**Project:** Bulk Fuel Upgrade Project On behalf  
of The City of Shishmaref, Alaska

**Solicitation No.:** 16004

**Addendum No. One**

**1 FACILITY FILL PIPELINE PLAN**  
SCALE: GRAPHIC

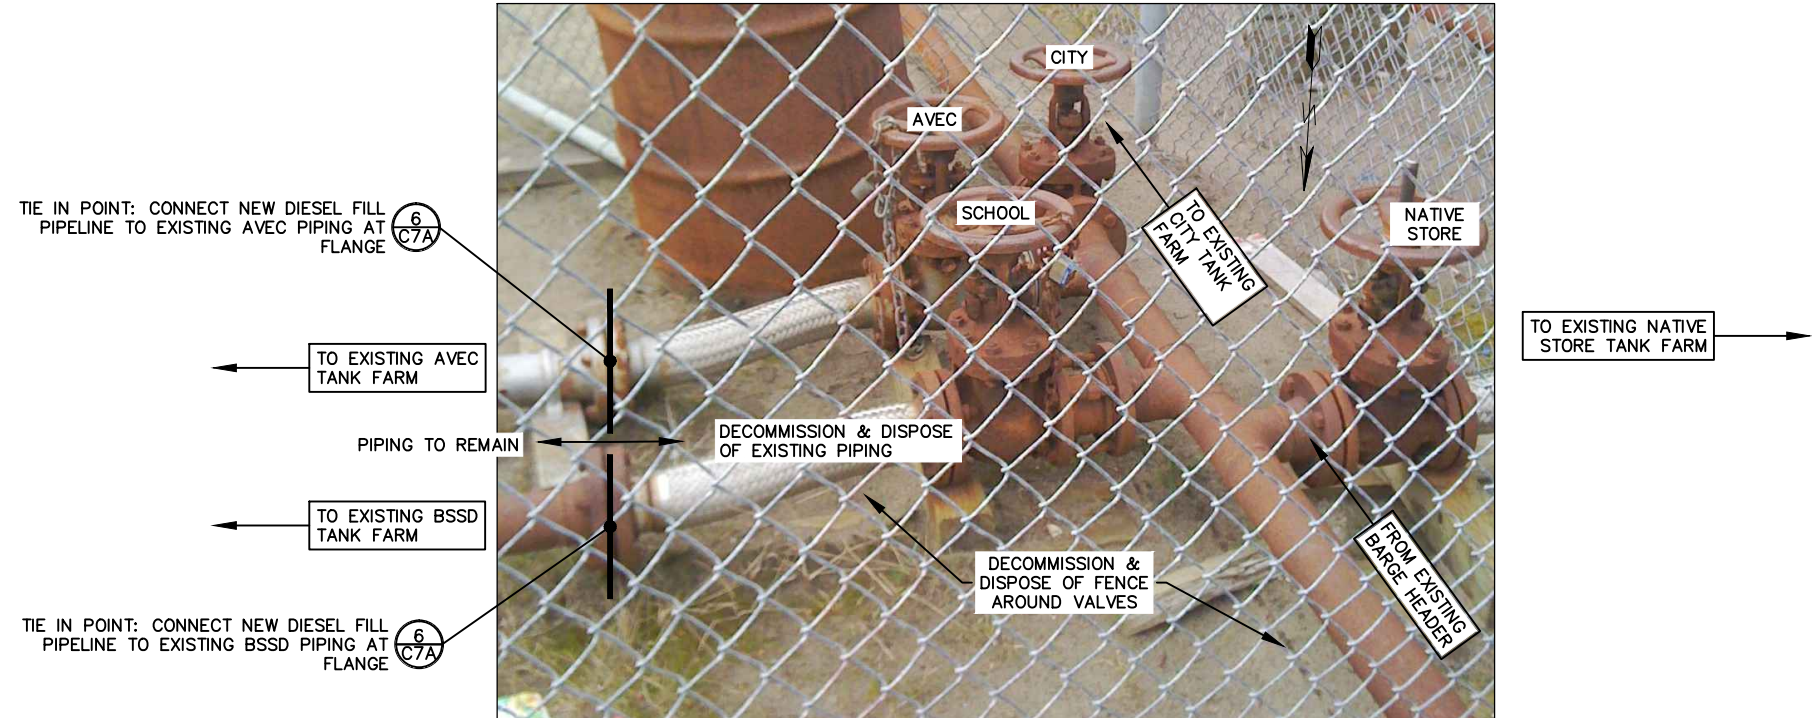
5) **Appendix A, Shishmaref BFU Plan Set:** Replace sheet C7 with the attached revised sheet C7 (attachment three, one page).

- NOTES:**
1. DECOMMISSION & DISPOSE OF EXISTING VALVES, PIPING & FENCE SHOWN IN 2/C7. REPLACE WITH 3WAY VALVE ASSEMBLY & ENCLOSURE SHOWN IN 6/C7A.
  2. SYSTEM REPRESENTATIONS ON THIS SHEET ARE SCHEMATIC.
  3. SEE SHEET-C23 FOR PIPING DECOMMISSIONING EXTENTS.
